**ATTACHMENT C**

**ODCM, Revision 22**

**OFFSITE DOSE CALCULATION MANUAL**

**NUCLEAR GENERATION SITE**

FIGURE 4-5 SONGS 2 and 3 Radioactive Liquid Waste Treatment Systems

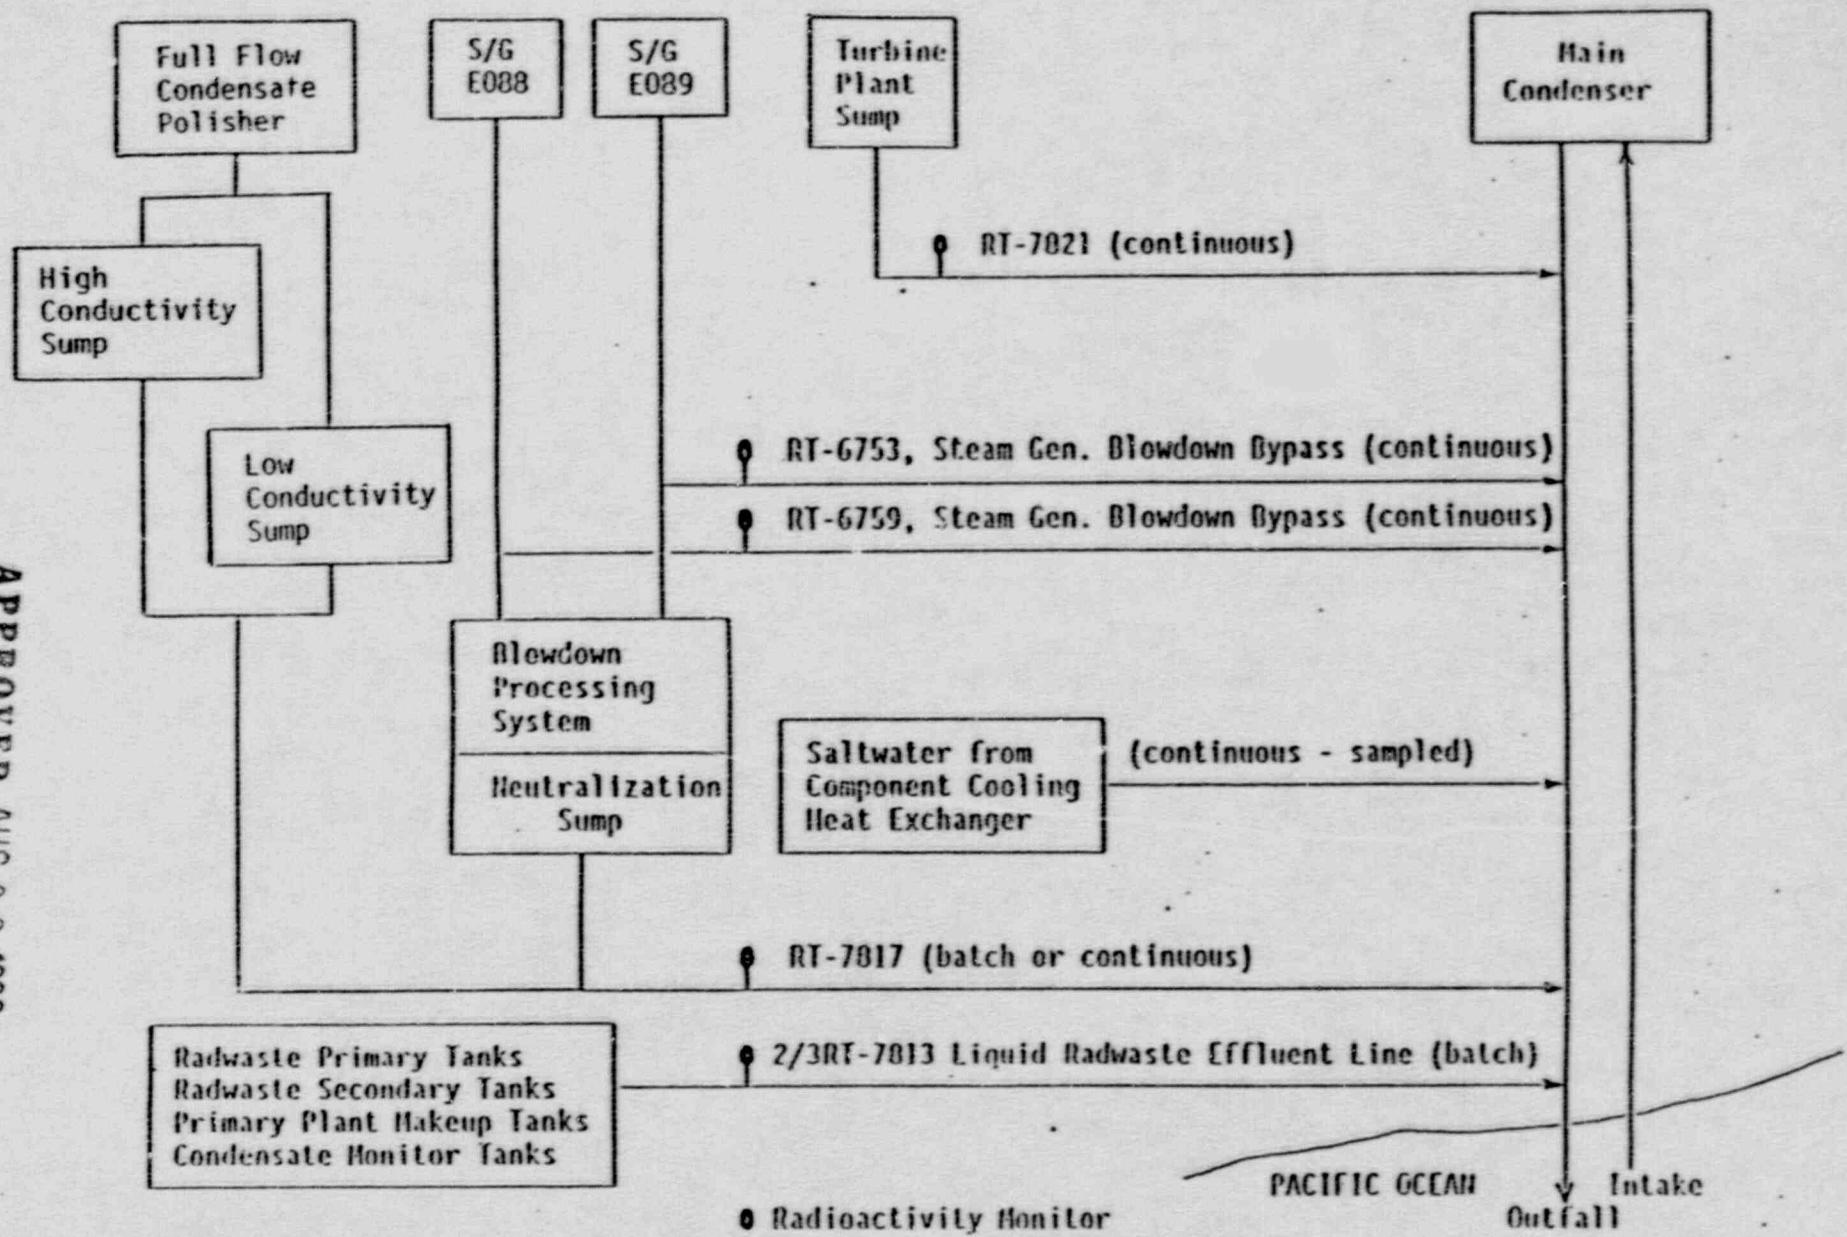
Comment 16: "One of the "Unit 2" designations associated with Primary System Degassing and Tank Cover Gases in Figure 4-1 should be changed to "Unit 3."

Comment 17: "Figures 4.1 and 4.2 should indicate all release pathways and monitors of liquid and gaseous effluents consistent with the release pathways and monitors identified in Sections 1.1 and 2.1."

**Comment 16:** "One of the "Unit 2" designations associated with Primary System Degassing and Tank Cover Gases in Figure 4-1 should be changed to "Unit 3."

**Comment 17:** "Figures 4.1 and 4.2 should indicate all release pathways and monitors of liquid and gaseous effluents consistent with the release pathways and monitors identified in Sections 1.1 and 2.1."

Response: The comment was resolved. Figures 4-5 and 4-6 were revised in Revision 21, and they correctly reflect unit designations.

Response: The comment was incorporated. Figures 4-5 and 4-6 were revised and are consistent with Sections 1.4 and 2.6.

**Response:** The comment was resolved. Figures 4-5 and 4-6 were revised in Revision 21, and they correctly reflect unit designations.

**Response:** The comment was incorporated. Figures 4-5 and 4-6 were revised and are consistent with Sections 1.4 and 2.6.
